# Request for Proposal

Date: 8/9/2023  
Project Name: UA 310 ARKV Renovation  
Project No.: 21085  
Owner: University of Arkansas - Fayetteville

**RFP NO: 02**

PROPOSAL REQUEST NUMBER: TWO (2)

# M1.01

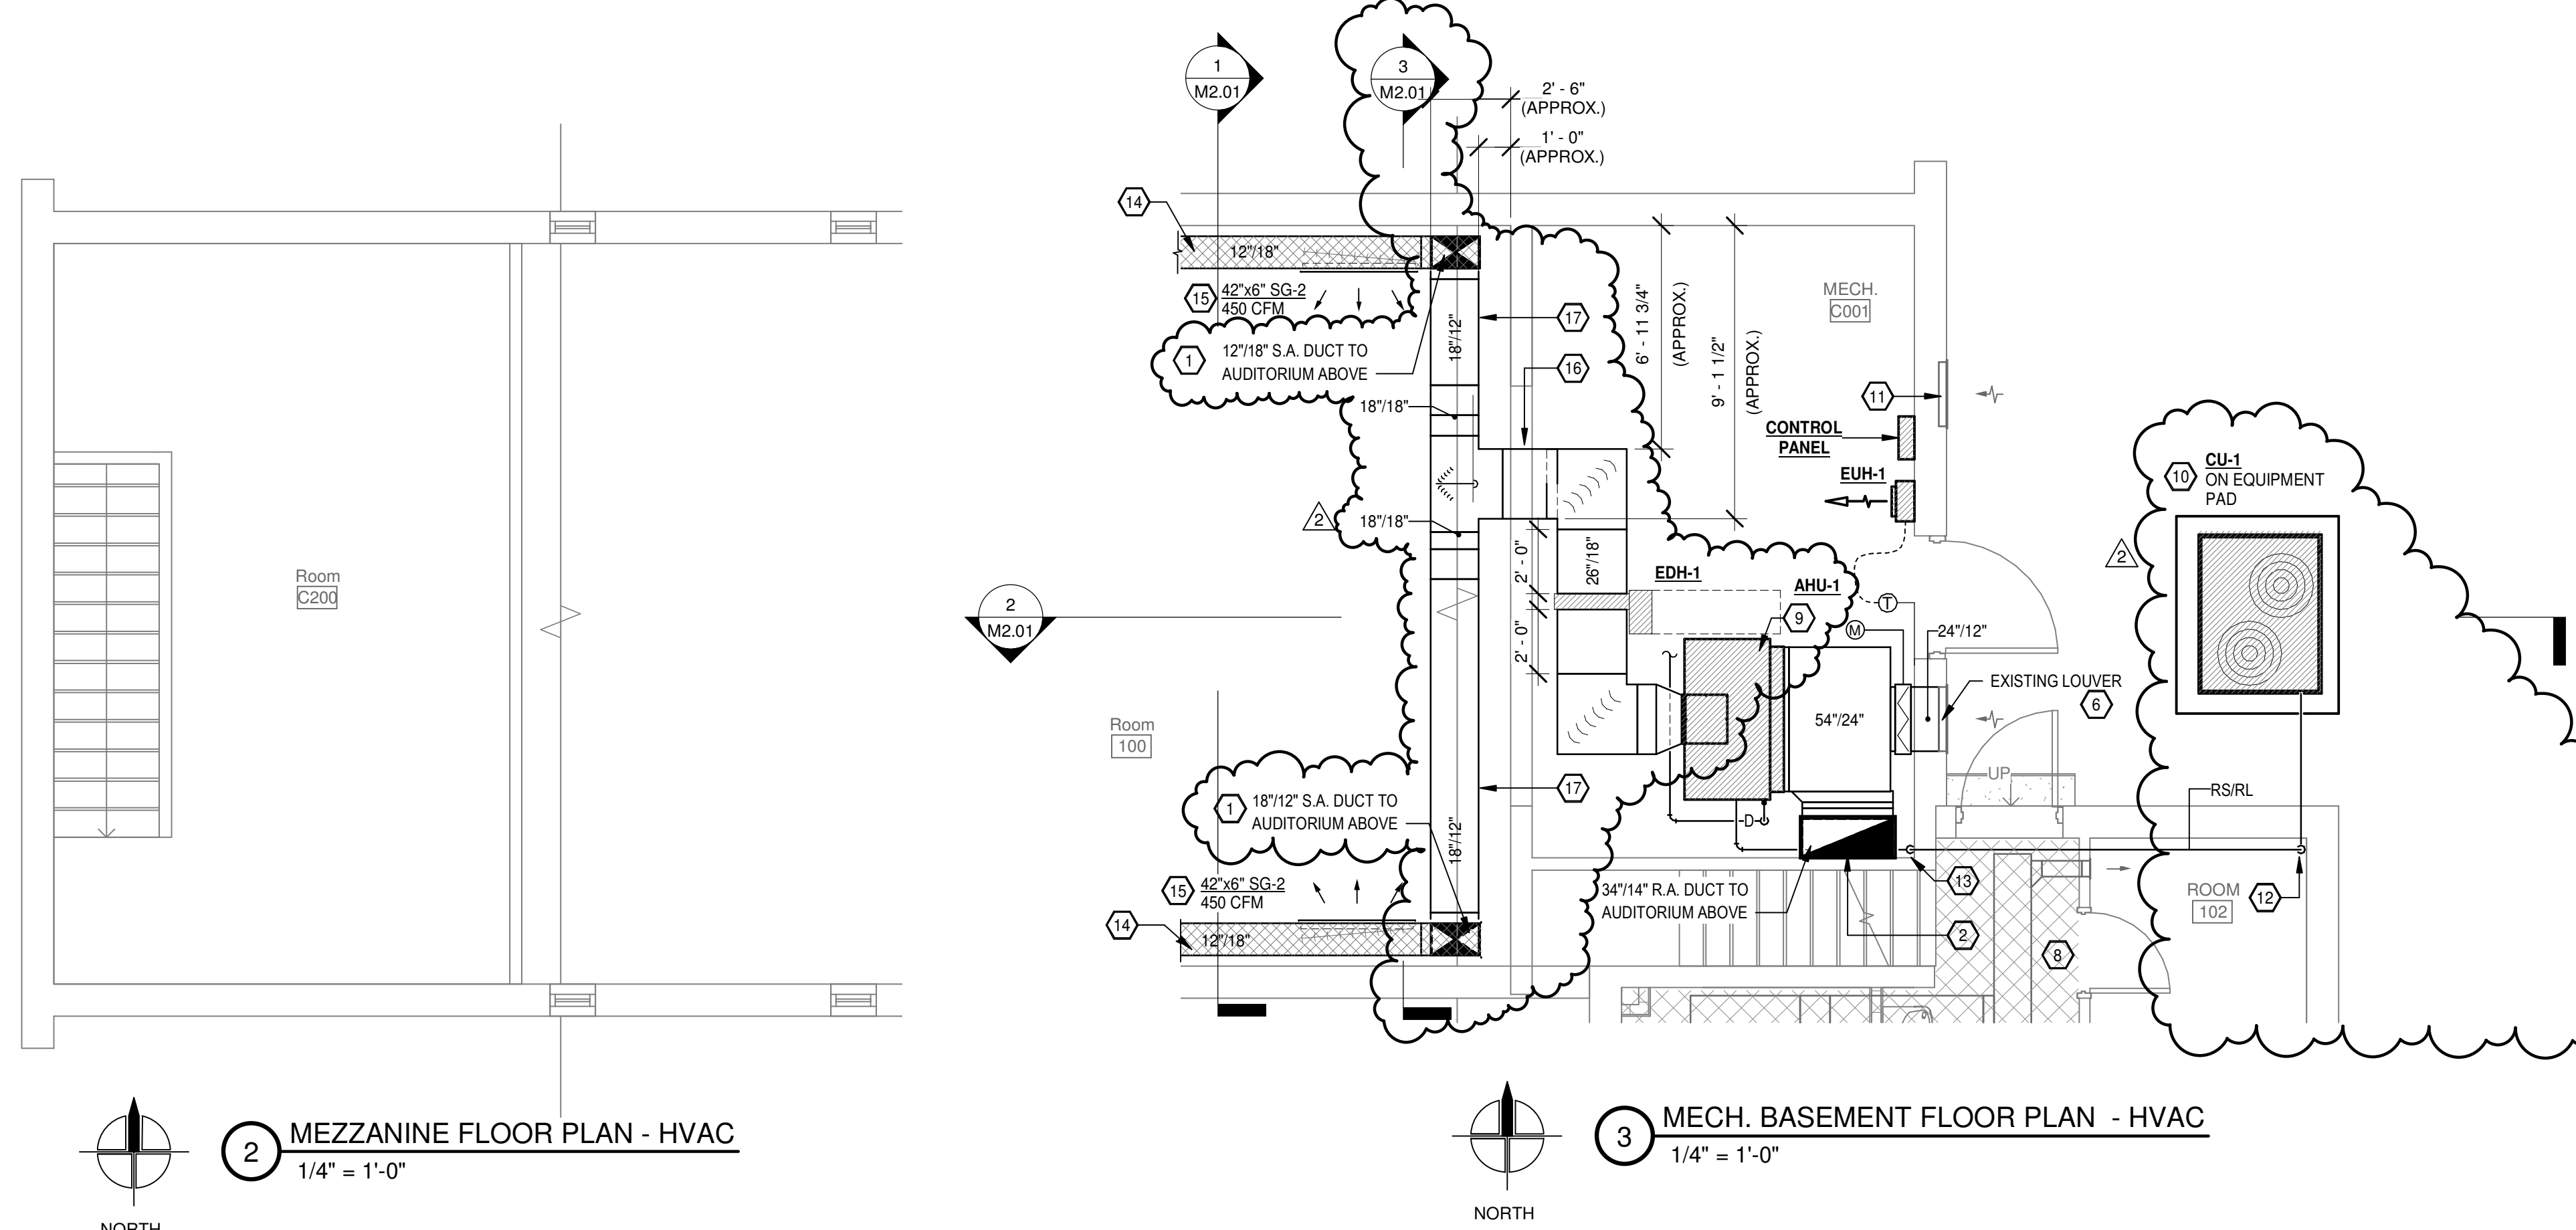
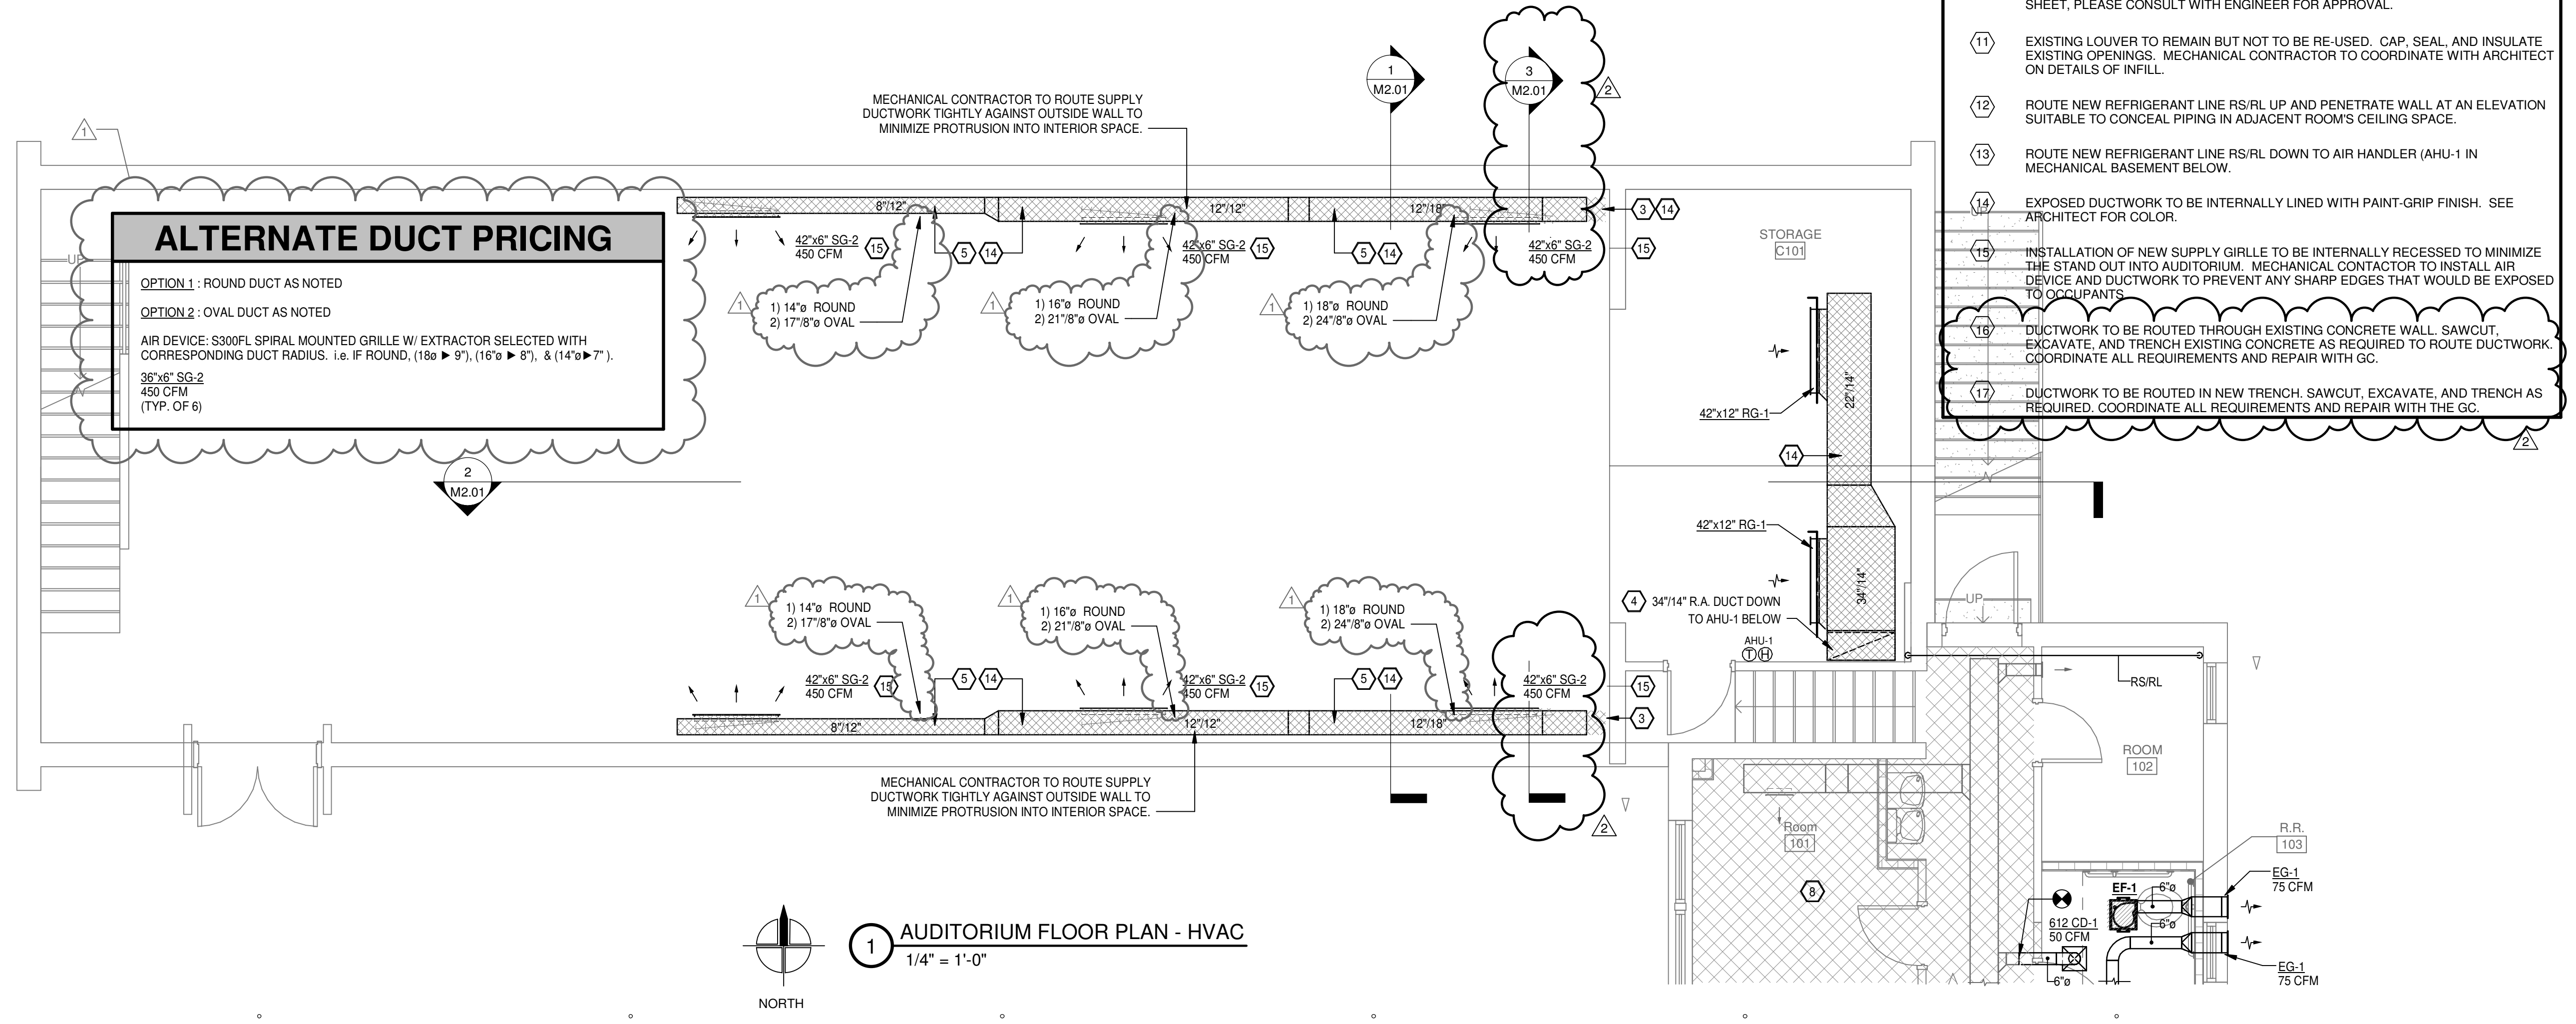
- A1.** REFER TO SHEET M1.01 AND M2.01 FOR DUCTWORK ROUTING REVISIONS. ADDITIONALLY, EDH-1 HAS BE REVISED AND RELOCATED, EDH-2 HAS BEEN DELETED, AND CU-1 HAS BEEN RELOCATED.
- A2.** REFER TO SHEET M4.01 REVISIONS TO THE DUCT HEATER SCHEDULE.
- A3.** REFER TO SHEET M5.01 REVISIONS TO THE DUCT HEATER CONTROLS DIAGRAM AND SEQUENCE OF OPERATIONS.
- A4.** REFER TO SHEET E1.03 FOR REVISIONS TO THE DUCT HEATER EDH-1 AND THE DELETION OF EDH-2. CU-1 WAS ALSO RELOCATED.
- A5.** REFER TO SHEET E2.01 FOR REVISIONS TO PANEL "A". A NEW 125A/3P BREAKER SHALL BE PROVIDED FOR EDH-1. THE ORIGINAL BREAKERS FOR EDH-1 AND EDH-2 SHALL BE LABELED AS SPARE.

- DUCTWORK TO BE ROUTED THROUGH EXISTING CONCRETE WALL. SAWCUT, EXCAVATE, AND TRENCH EXISTING CONCRETE AS REQUIRED TO ROUTE DUCTWORK. COORDINATE ALL REQUIREMENTS AND REPAIR WITH GC.

- DUCTWORK TO BE ROUTED IN NEW TRENCH. SAWCUT, EXCAVATE, AND TRENCH AS REQUIRED. COORDINATE ALL REQUIREMENTS AND REPAIR WITH THE GC.

### ALTERNATE DUCT PRICING

**OPTION 1** : ROUND DUCT AS NOTED  
**OPTION 2** : OVAL DUCT AS NOTED

AIR DEVICE: S300FL SPIRAL MOUNTED GRILLE W/ EXTRACTOR SELECTED WITH CORRESPONDING DUCT RADIUS. I.E. IF ROUND, (18" ▶ 9"), (16" ▶ 8"), & (14" ▶ 7").
